June 8, 2022

Subject: **Response to Geotechnical Peer Review Comments Regarding  
2204-107-SUB1-PLANS**

Proposed Mercer Island Treehouse Residence  
5637 East Mercer Way  
Mercer Island, Washington

# Soil Liquefaction Analysis Report

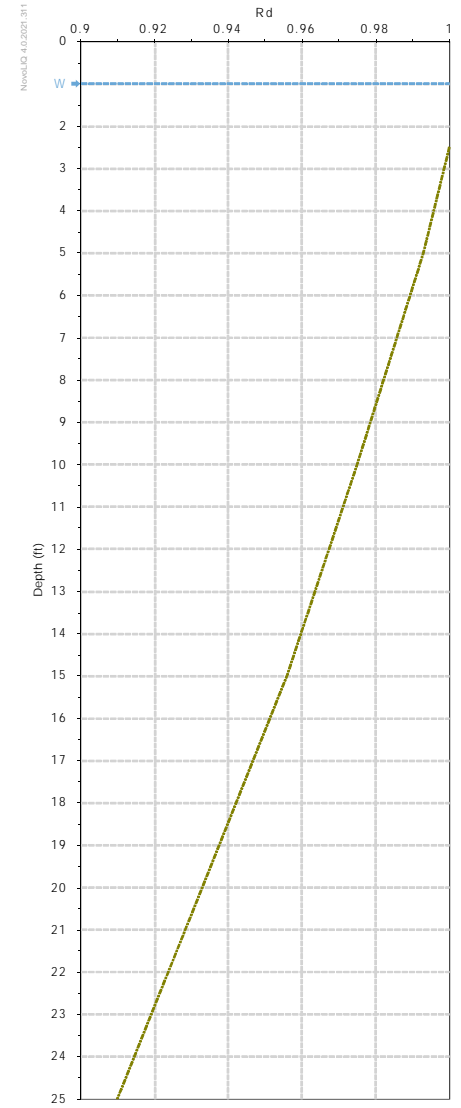
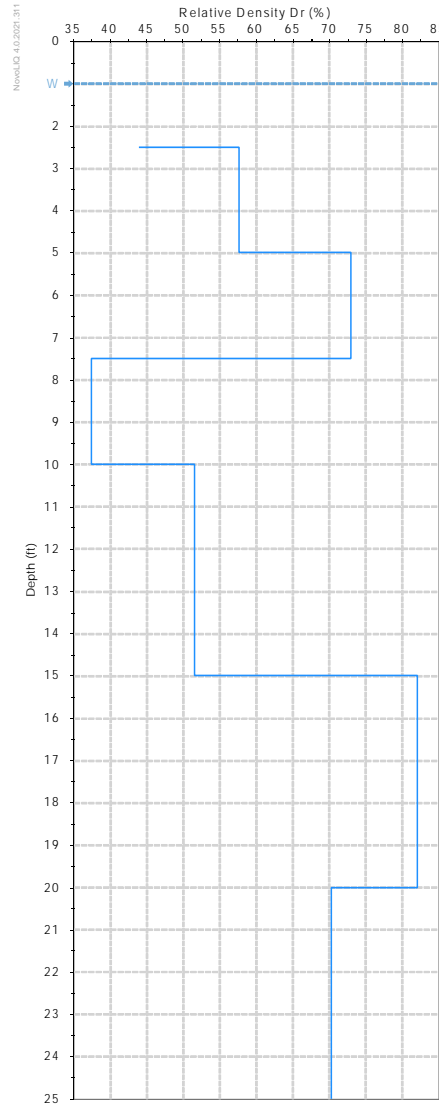
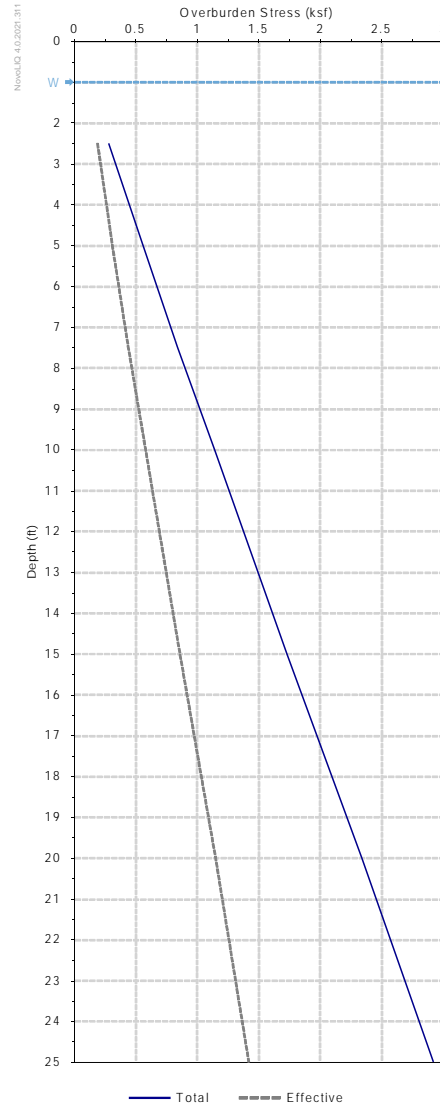
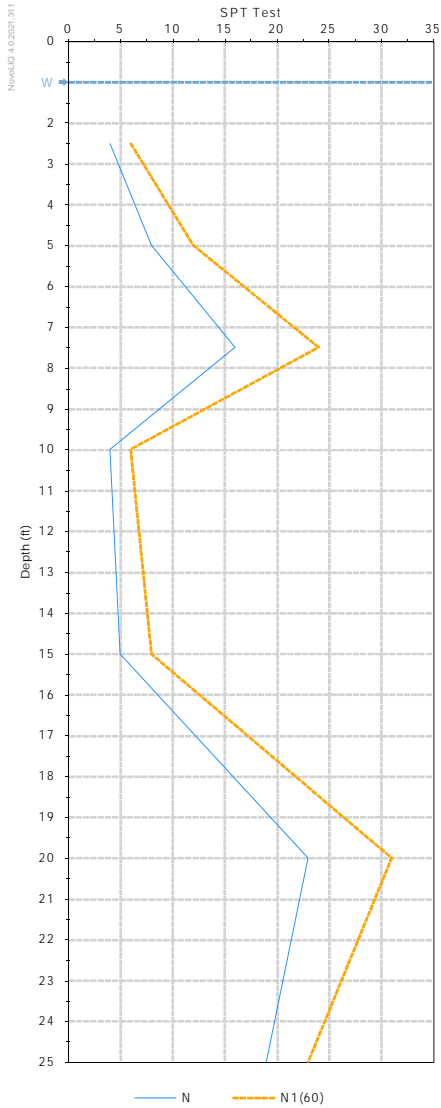
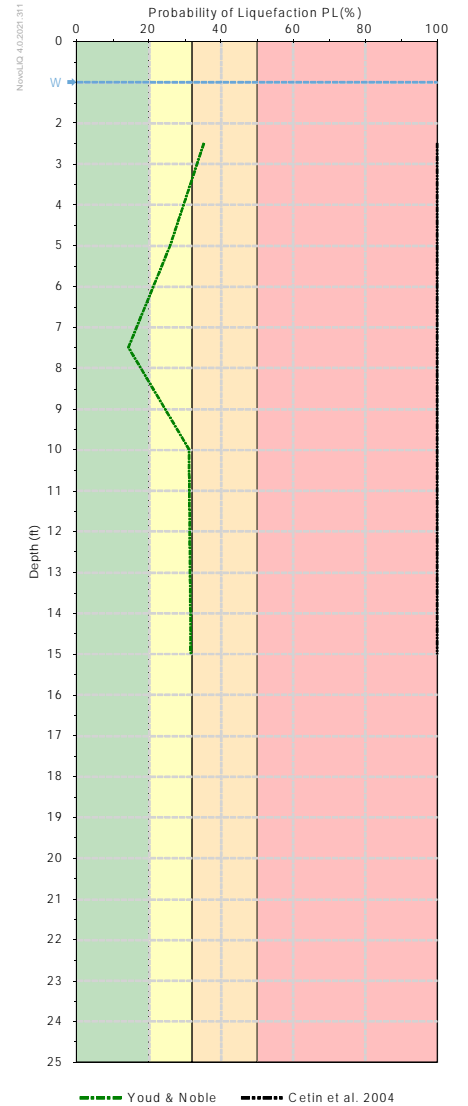
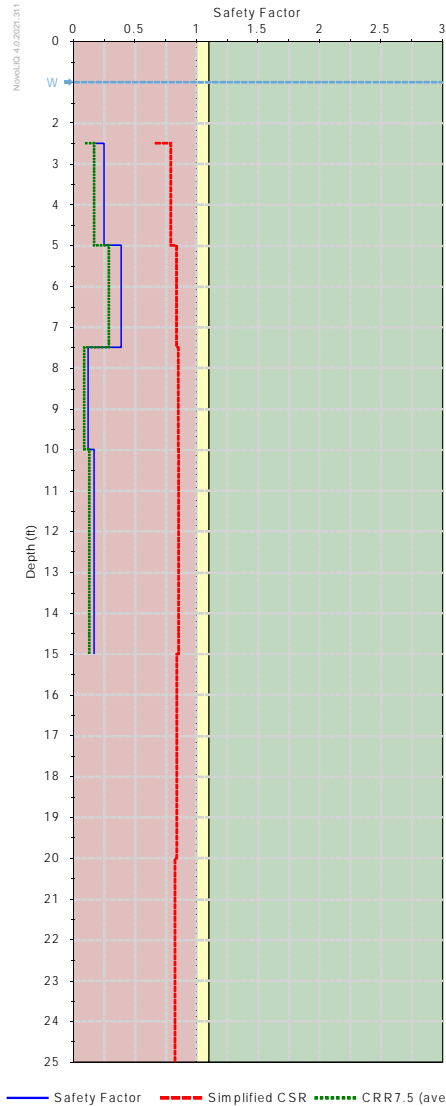
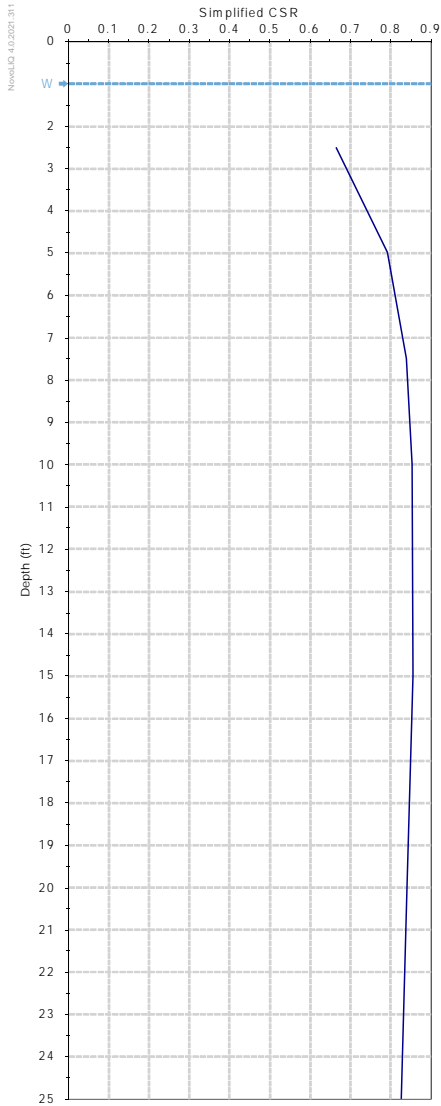
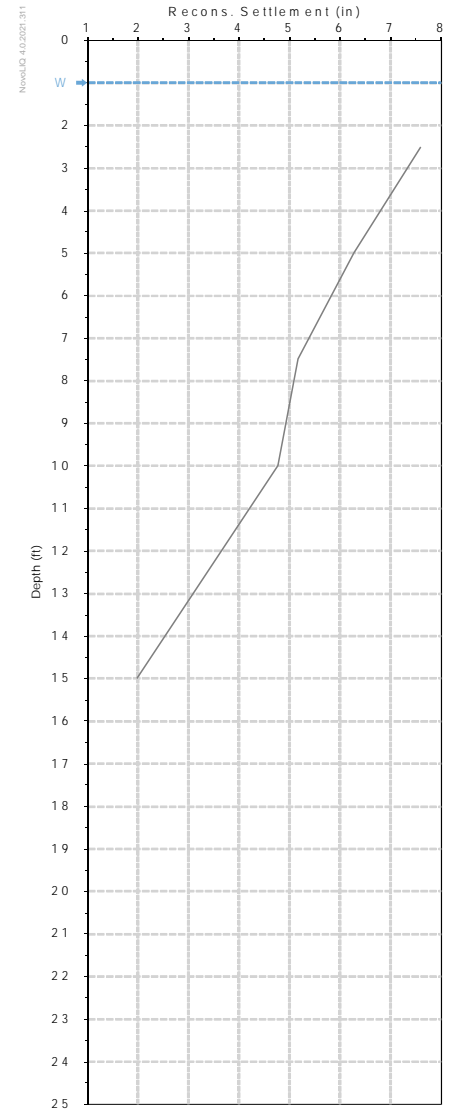
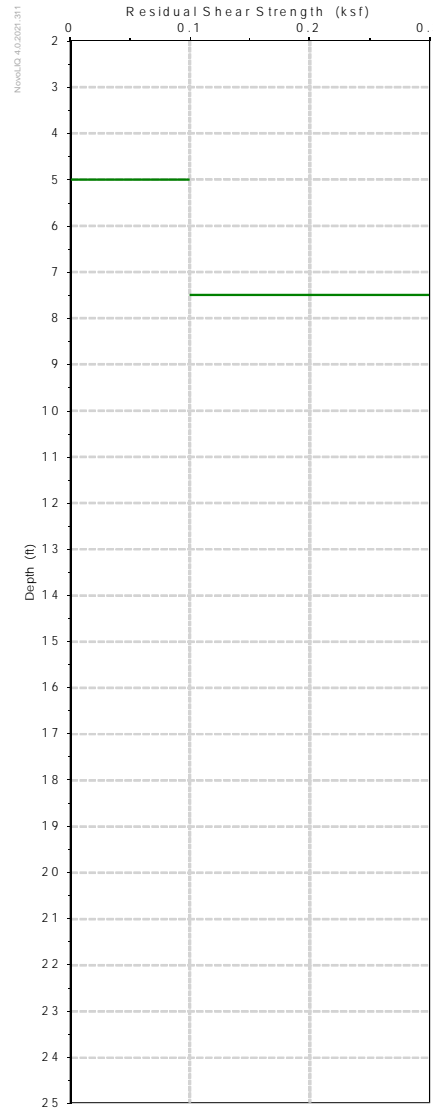
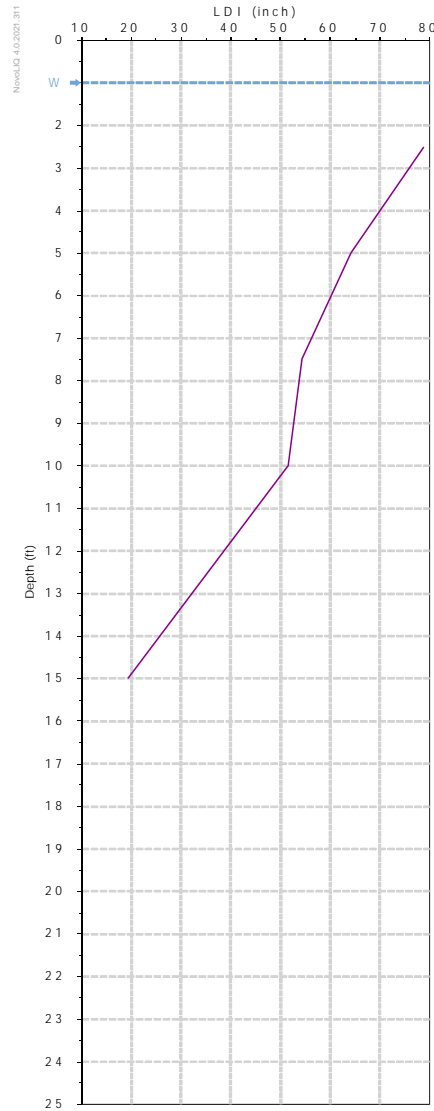
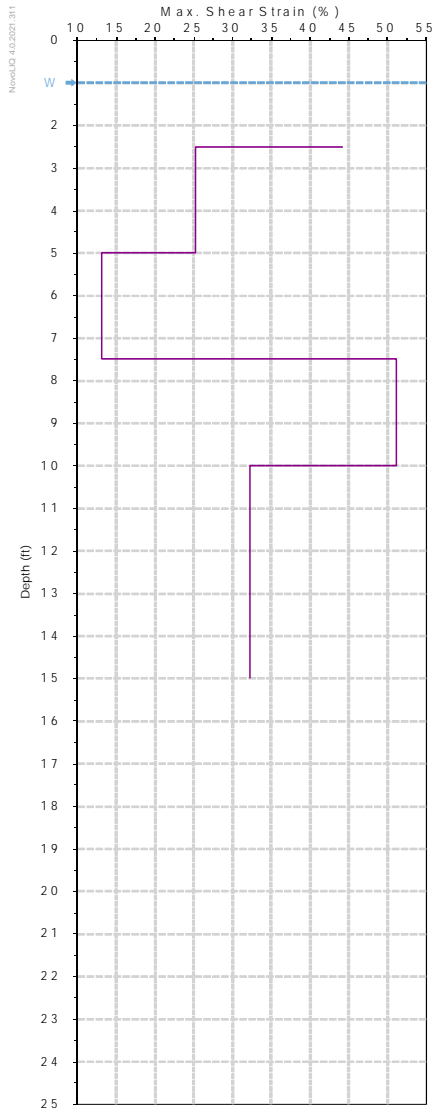
**Number: 2** *The geotechnical report dated 3/12/2015 indicated that the site soils are liquefiable. The geotechnical engineer should assess to what depth these soils are liquefiable. What is the estimated post-liquefaction settlement? What is the potential for lateral spreading or flow failure? What magnitude of lateral deformation is estimated? Include discussion of how the post-liquefaction condition impacts the proposed structural design, for example, piling embedments, lateral earth pressures associated with a liquefied soil condition, lateral loading associated with flow failure or lateral spreading, etc. Provide mitigation recommendations for consideration by the project team. Provide this information with supporting calculations and stability analyses in a report addendum.*

**Response:** The potential for liquefaction and resulting ground settlement or soil bearing strength loss has been studied for many years, but it is still impossible to accurately determine where, and to what extent, liquefaction could/will occur. However, liquefaction of the loose sand soils that lie beneath the water table has a high probability during the Maximum Considered Earthquake (MCE), which has a probability of occurring once in 2,475 years.

Using NovoLIQ a maximum ground settlement of approximately 8 inches was calculated under the MCE. The results of this analysis are attached. The amount of actual ground settlement that could occur as a result of liquefaction will vary with differing soil conditions, and the magnitude, duration, and predominant direction of ground shaking associated with an earthquake.

The results of our lateral spreading analyses, which are attached, indicate that lateral ground movement of 12 to 19 feet could theoretically occur in the MCE. The theoretical lateral movements are large enough that no conventional pile system, drilled or driven, can prevent them from occurring, or can withstand the potential lateral movements without shearing off. It is important to note that these large potential movements are calculated using available methods are likely substantially overestimated for this site. The property lies at the upgradient boundary of any potential lateral spreading. The steep slope immediately west of the planned house is comprised of glacially-compressed soils that would not be affected by lateral spreading or deep instability in the event of the MCE. Also, the stability of the home site will be improved by the presence of the pipe piles and soldier pile walls, and the localized dewatering around and beneath the house, further reducing the potential for large lateral ground movements during the low probability earthquake.
